# RECORD OF DECISION

B906 - Page Industrial Area  
State Superfund Project  
Poughkeepsie, Dutchess County  
Site No. 314077  
March 2012

## **Responsiveness Summary**

**B906 - Page Industrial Area  
State Superfund Project  
Town of Poughkeepsie, Dutchess County, New York  
Site No. 314077**

PRAP Figure 6

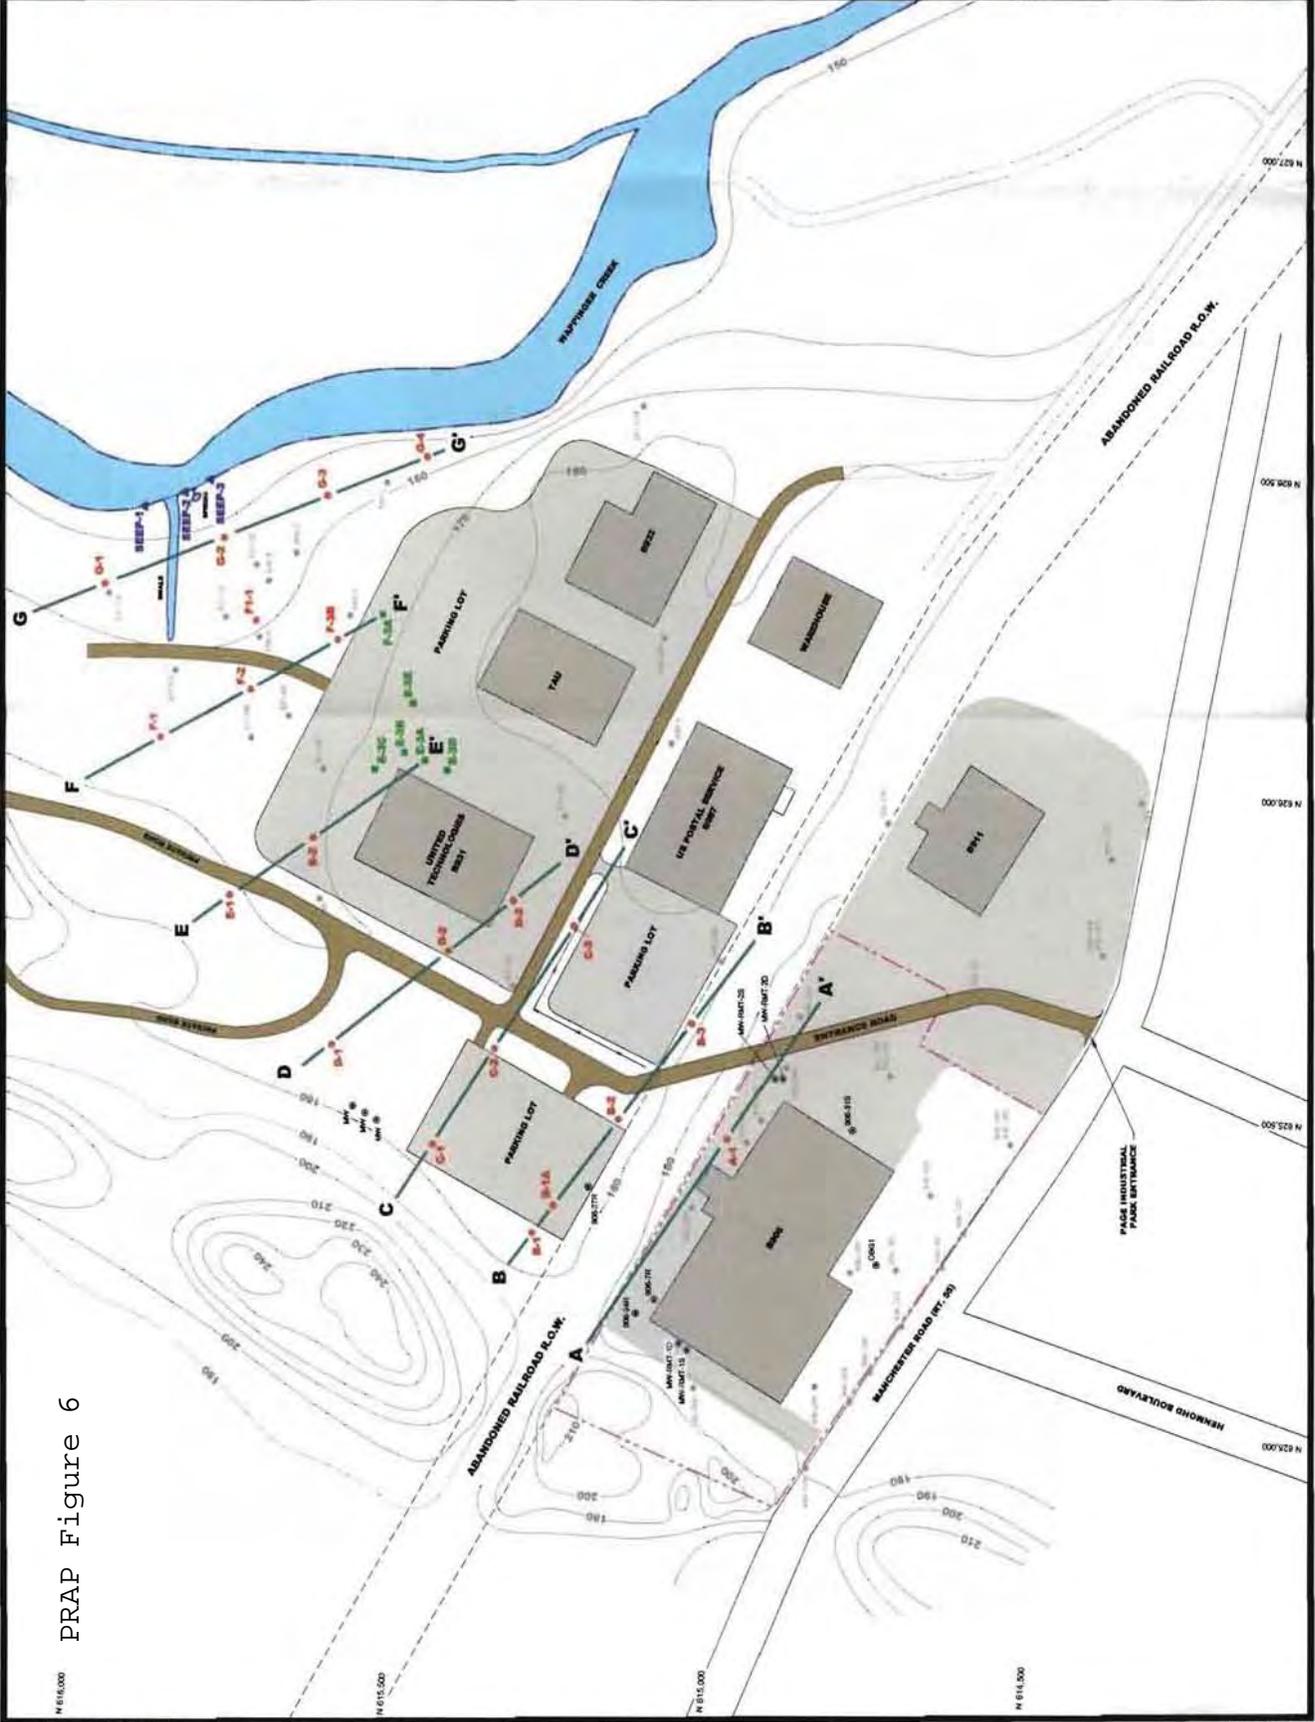
COMMENT 12: The reported concentrations are in ppb/parts per billion not ppm/parts per million. Hence the table and following paragraph should be removed from Exhibit A; or in the alternative change the table values and note there was no exceedance.

RESPONSE 12: The Table has been modified to reflect the correct units and shows that no soil exceeding SCOs were detected.

# PRAP Figure 7

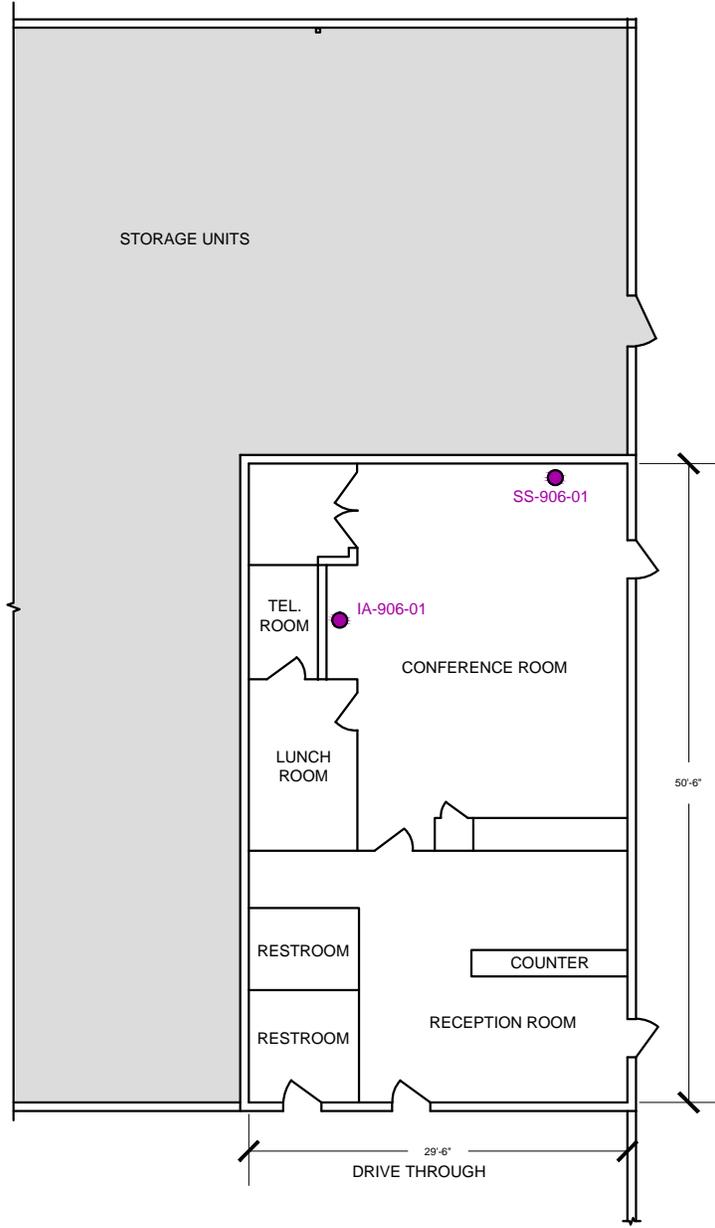
COMMENT 8: Reference to mitigation of soil vapor intrusion impacts should be "in the office area of the B906 Building". Similarly, on Page 8, paragraph 3, "in the office area of the B906 Building"....

COMMENT 11: Page 4 - Note only the office area for B906.

RESPONSE 8: The language in the ROD was modified to reflect that the soil vapor intrusion sampling was completed specifically in the office area of the B906 Building.

RESPONSE 11: The ROD has been updated to indicate that soil vapor intrusion sampling was completed only in the B906 office area. The ROD also states that mitigation is only for the office area of B906.
